Riverside @ Tea Gardens

**Modification to the Concept
Plan for Concept Approval
Number 10-0136**

October 2016

Reference 213366 – R001007 Modified Concept Plan

Figure 1- Site Area including MCP Layout

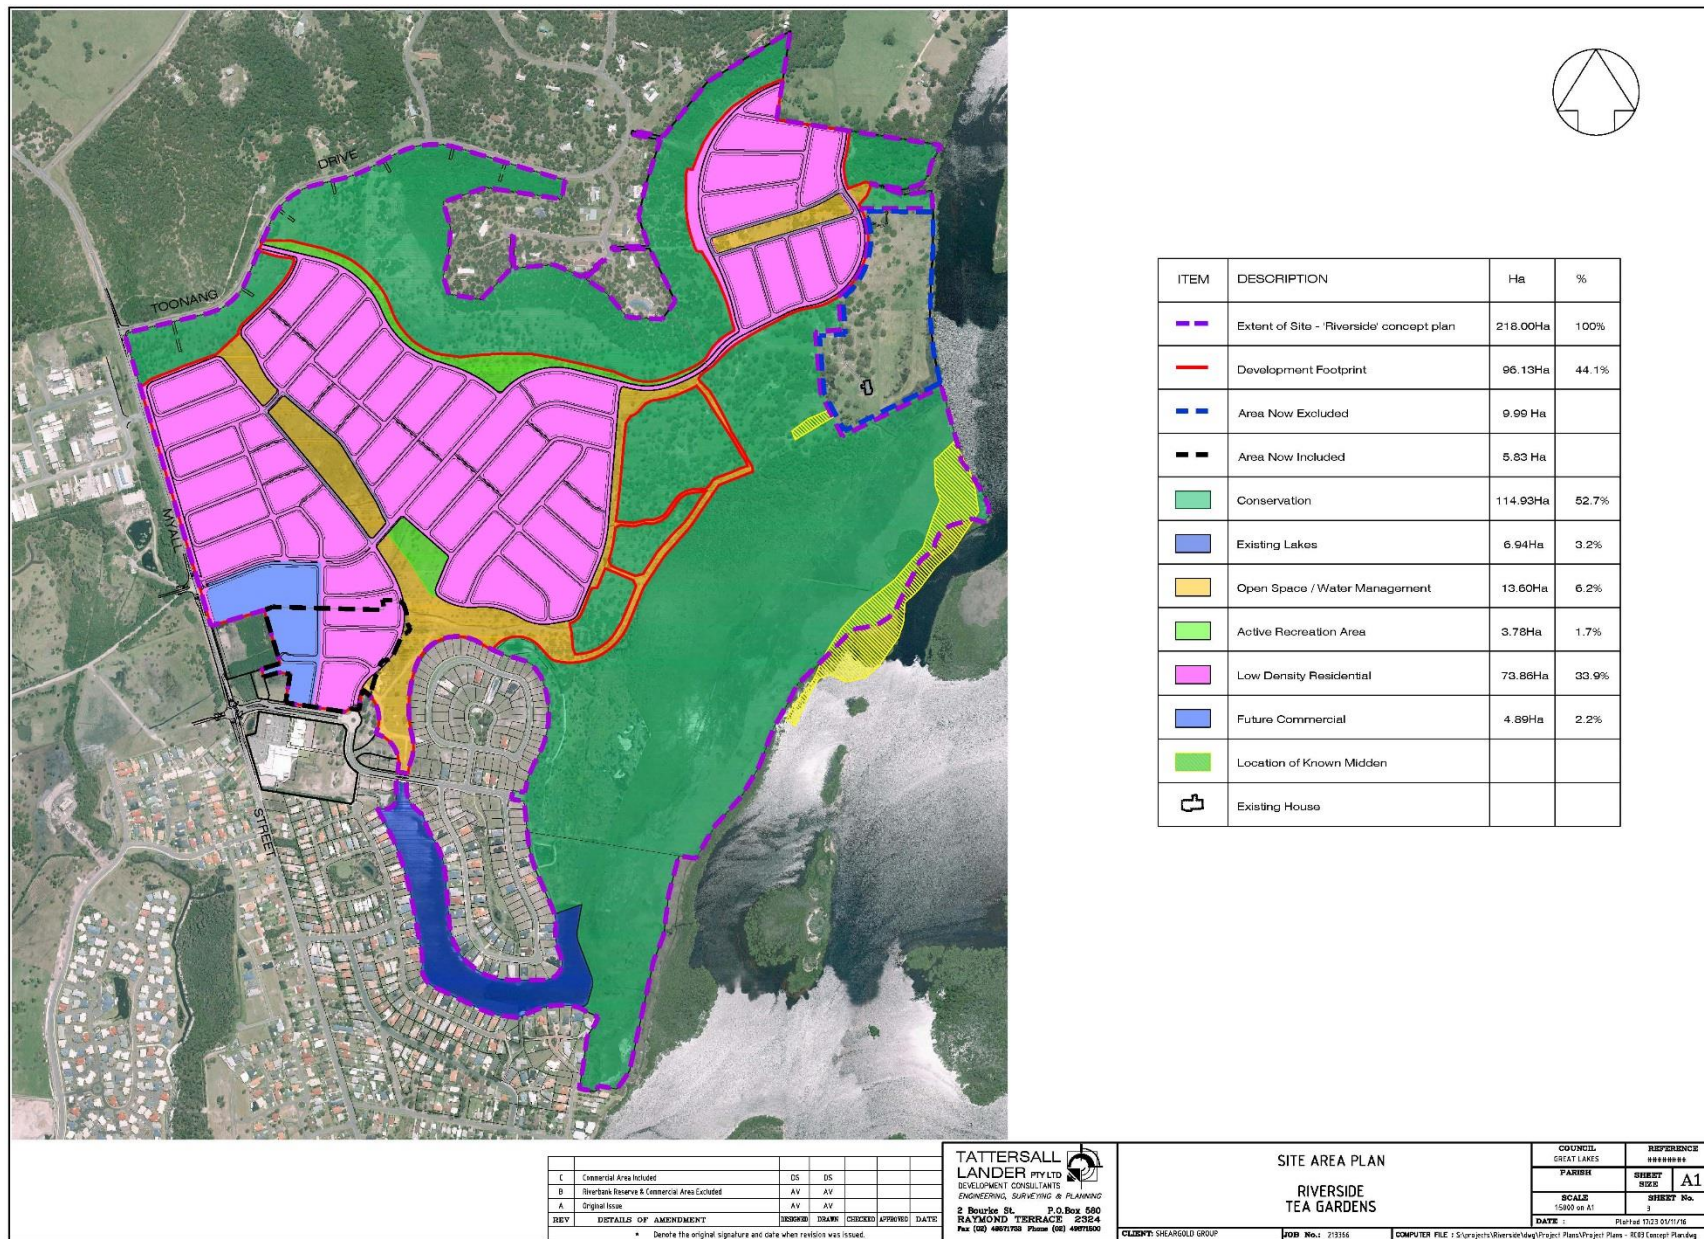
This MCP is proposing to modify the site boundary. An area of 9.99Ha of land is proposed to be excluded from the site to the northeast that was previously included in the concept approval. 5.83 Ha of land is proposed to be added to the site around the commercial precinct along Myall Street. (see Figure 1)

- An area of 9.99 Ha has been withdrawn from the Concept Plan, refer Figures 1 & 4, at the northeast part of the project and fronting the Myall River. Part of this area may be the subject of a planning proposal and subsequent application once discussions between Sheargold and Council are finalised as to the appropriate uses for this area. The other part will be retained as a private allotment containing the existing residential dwelling on the site.

Figure 7 – MCP Staging Plan

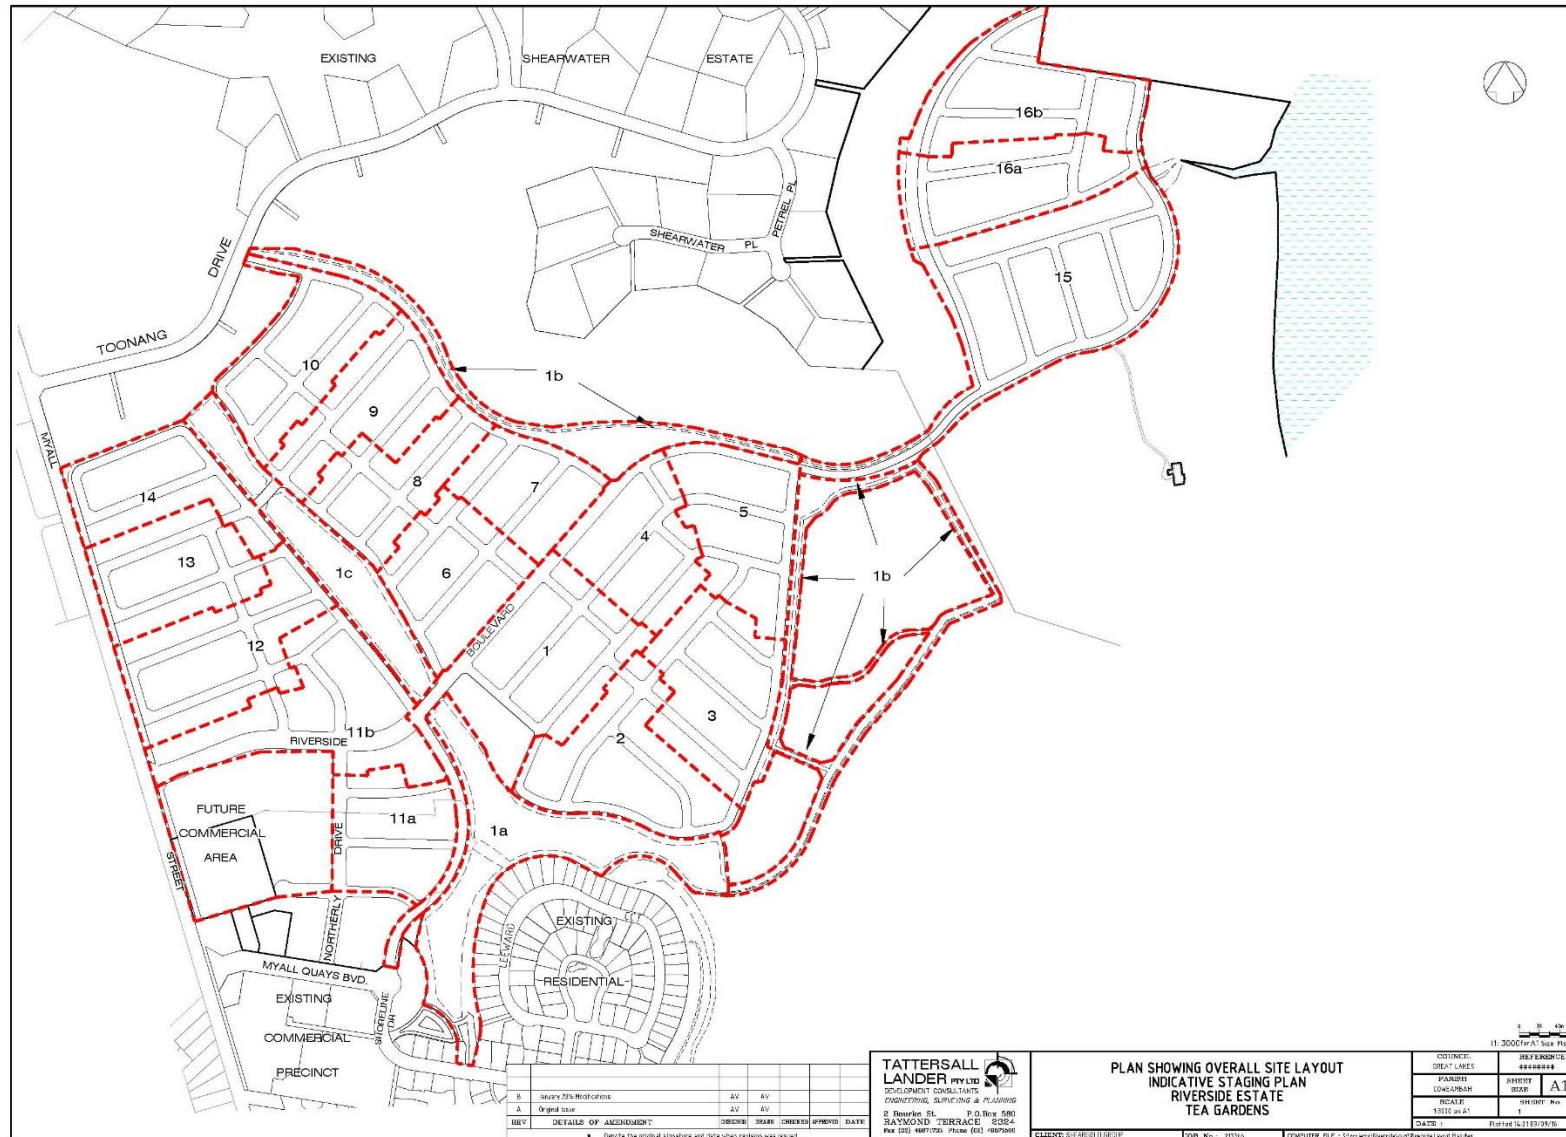
- The MCP layout now has 16 stages, refer Figure 7 and Annex A, and it is to be noted that the staging is not intended to be a sequential arrangement as market acceptance will be the driving force for the long-term development of the land. It is proposed that the development initially concentrate on Stages 1 to 5 and the main services (access, electrical/communications and water) for these stages be utilised through the extension of those services northwards along Shoreline Drive. Previous upsizing of these services have seen appropriate terminations occurring at the Shoreline Drive/Myall Quays Boulevard roundabout.

Figure 8 – MCP Bulk Earthworks Plan

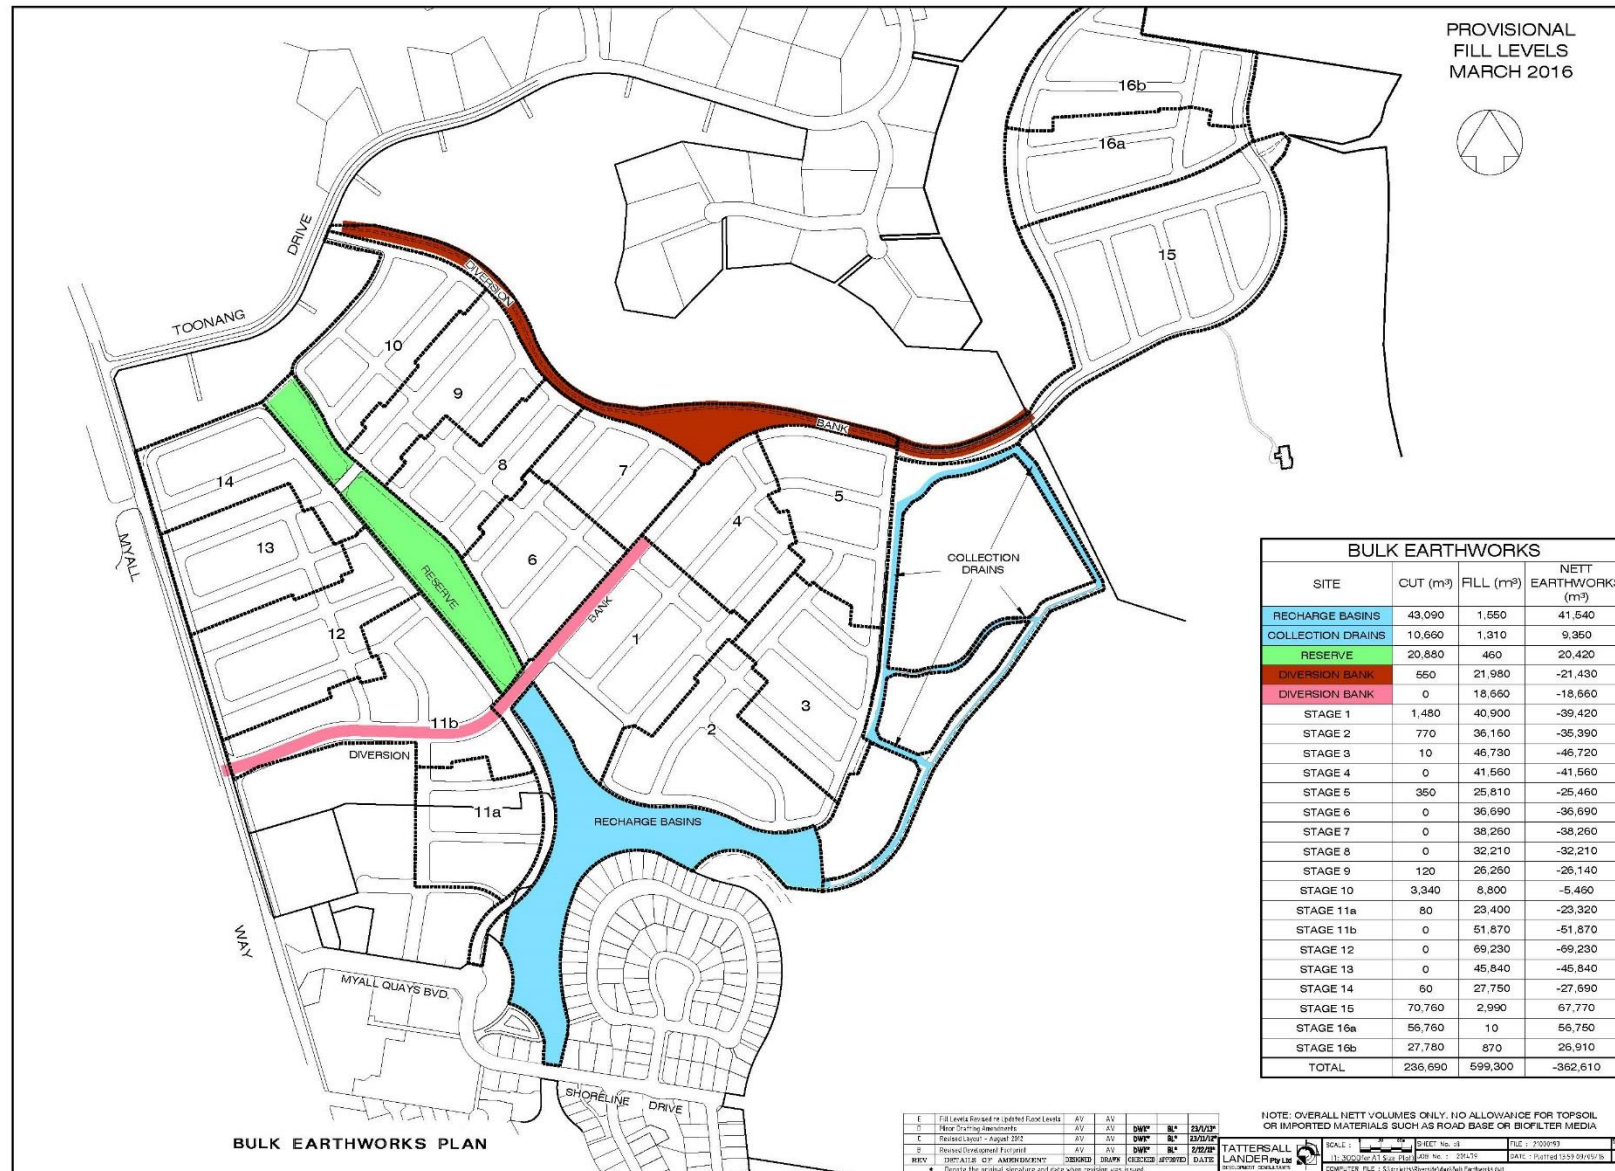
- In conjunction with the development of Stages 2-5, it is proposed to undertake bulk earthworks in stages 15 and 16 to win fill material for the development of these initial stages, refer Figure 8, for an indication of the intended movement of fill material around the site. Stage 1 and the proposed embankment and drainage corridor works are effectively a cut fill operation and the Bulk Earthworks Table associated with Figure 8 confirms this arrangement. Stages 2-5 require the importation of fill and logically this will be sourced from the adjoining Stages 15 and 16 where additional sand fill over and above the design surfaces exist.

Figure 10 – Proposed Intersection Treatment at Myall Quays Boulevard

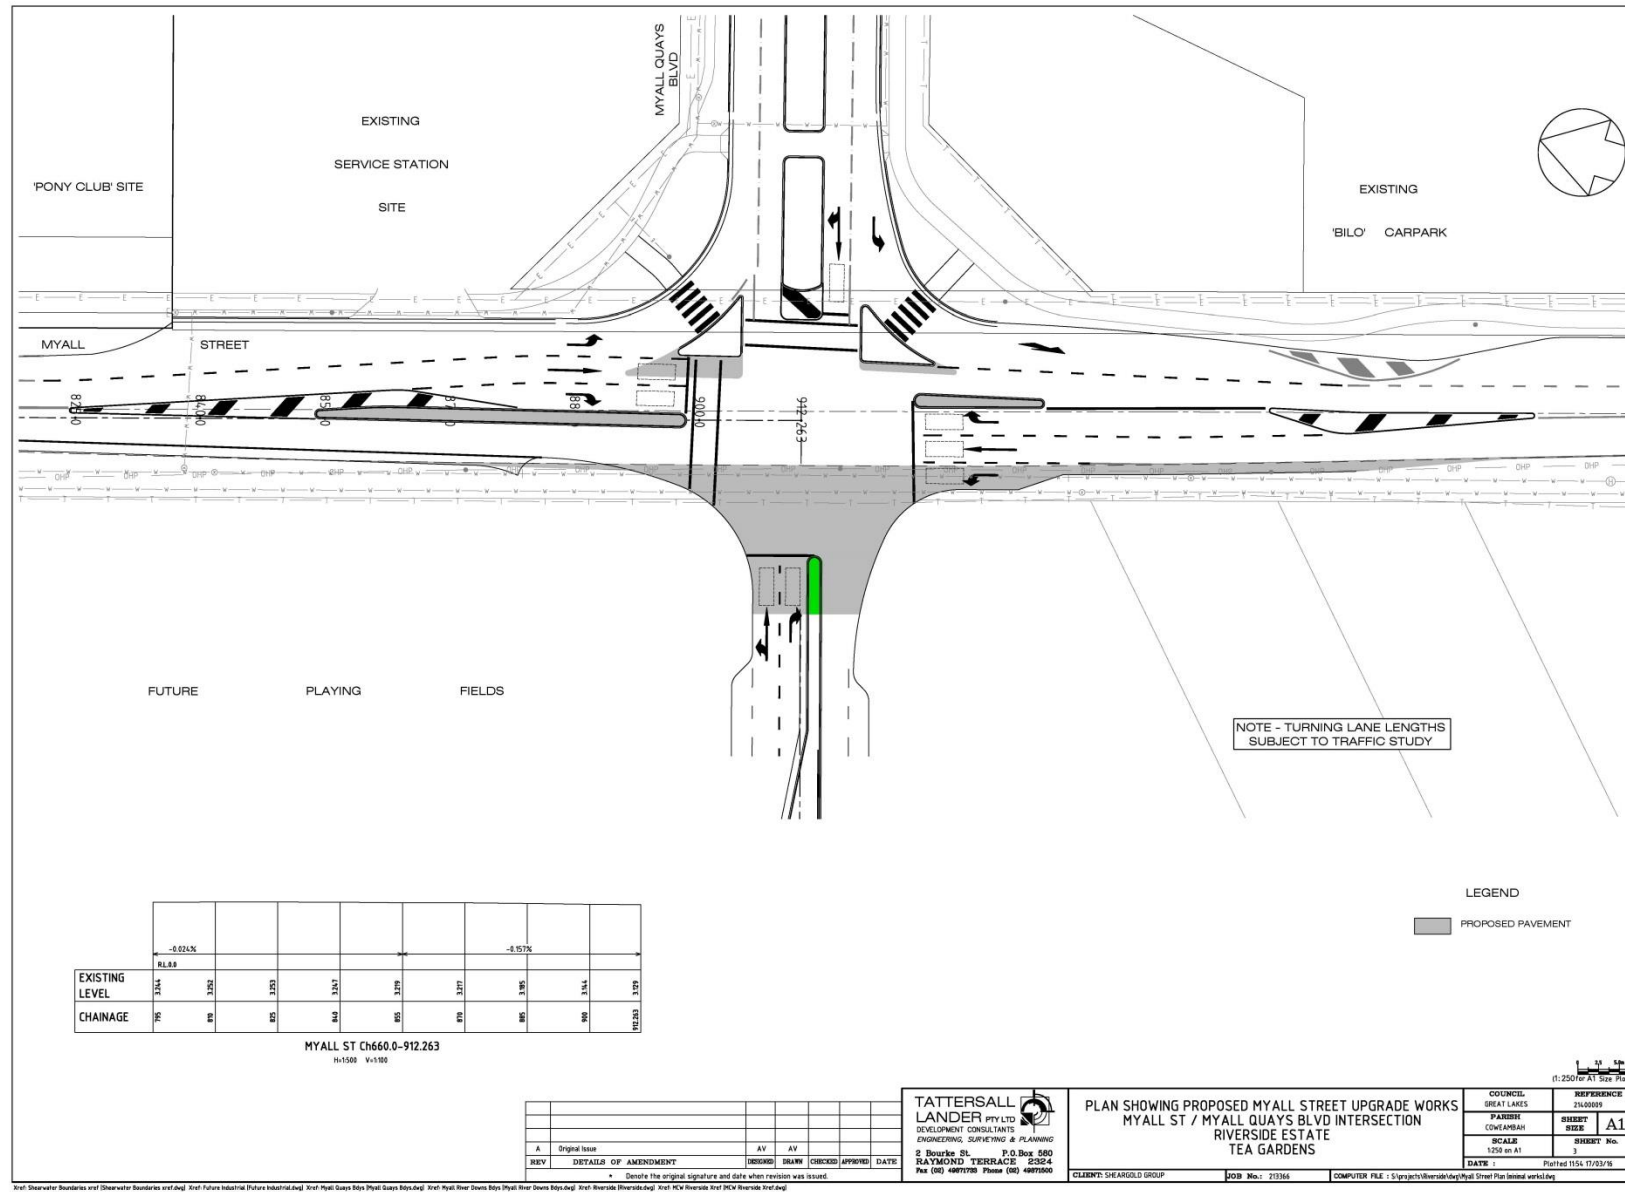
Council has agreed that this intersection geometry will be as per Figure 10 below. Annex L contains that confirmation. The construction and signalisation of the intersection is now a Section 94 Contribution and the reasons for this process have been discussed previously. The installation timings for the signalisation of the intersection will be a matter that is determined by Council. Further discussions with

Condition to be deleted as this item is now a Section 94 Contribution item and under the control of Council. Figure 10 provides the Council agreed position.

Figure 11 – Proposed Intersection Treatment at Riverside Boulevard

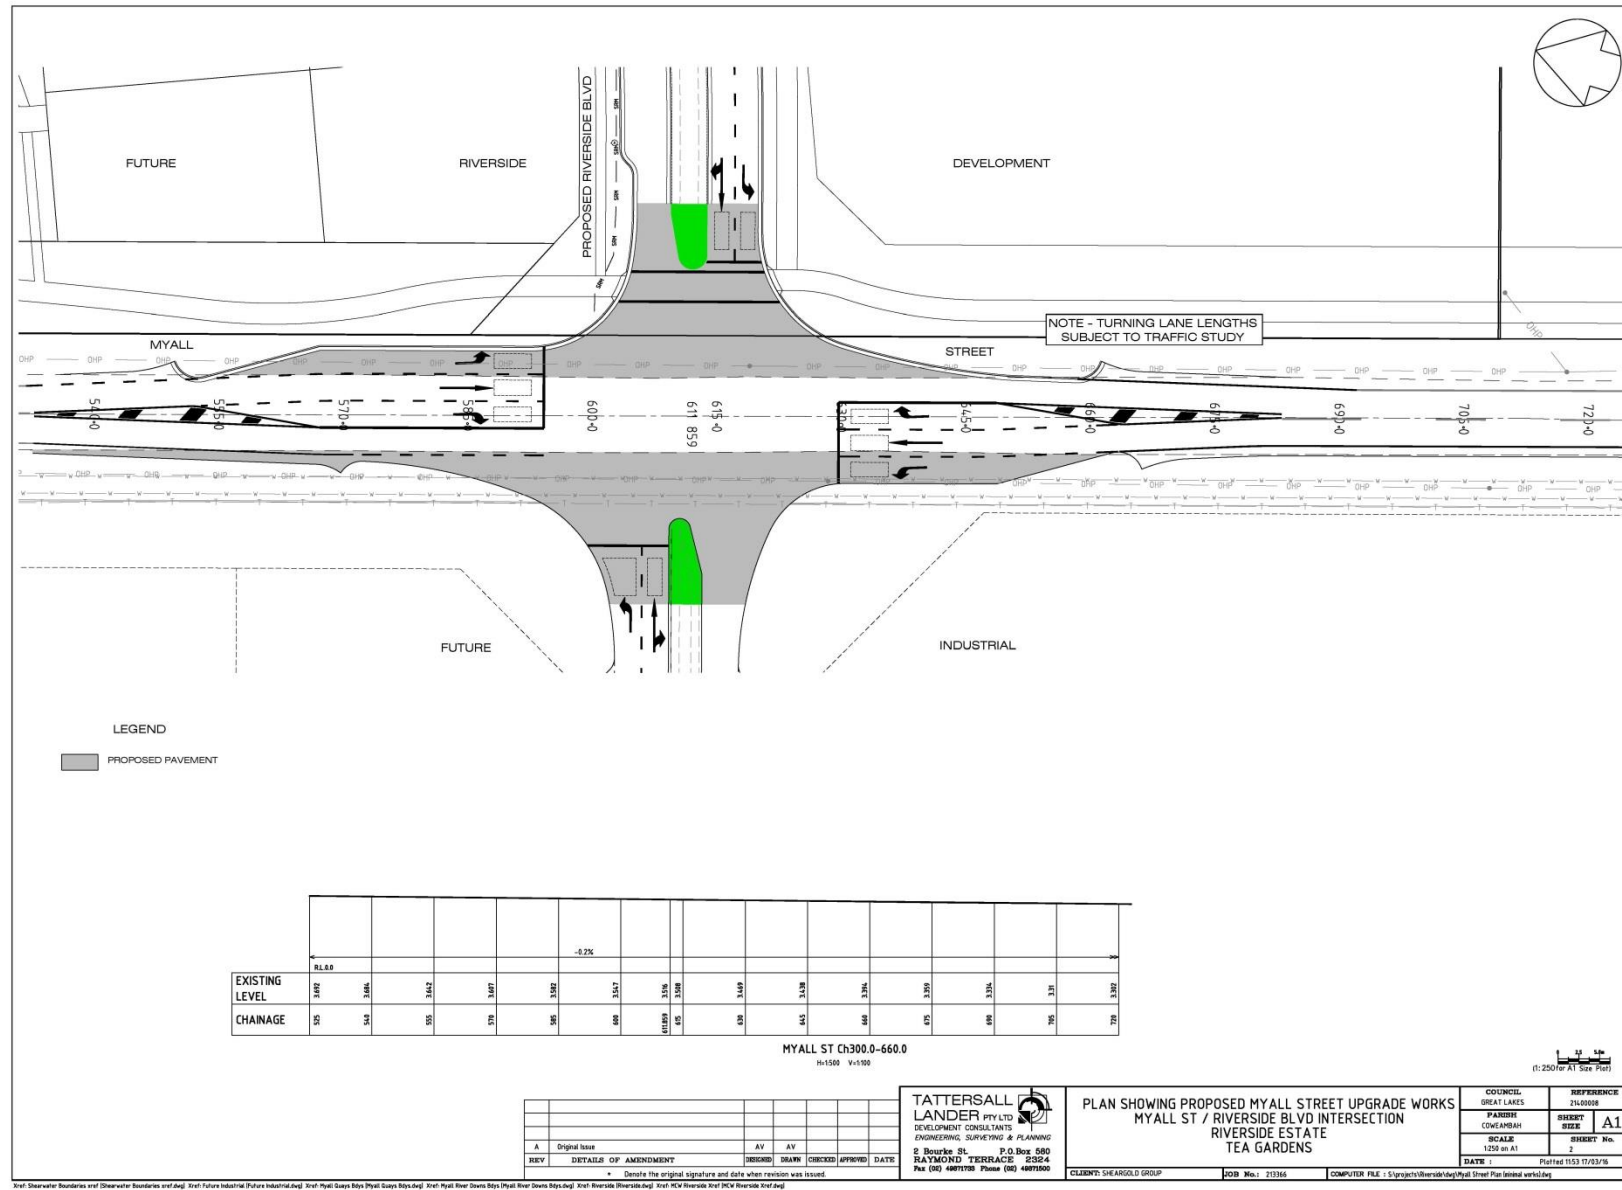
The intersection geometry of Riverside Boulevard has been confirmed by Council and is shown in Figure 11 below. Matters relating to the timing of the intersection in relation to the development staging and signalisation works have been addressed above. Irrespective of the amended TIA attached to this report, it is the intention of the proponent to undertake the construction of a second Myall Street intersection around the opening of the 7th Stage of the development and the Statement of Commitments has been noted accordingly.
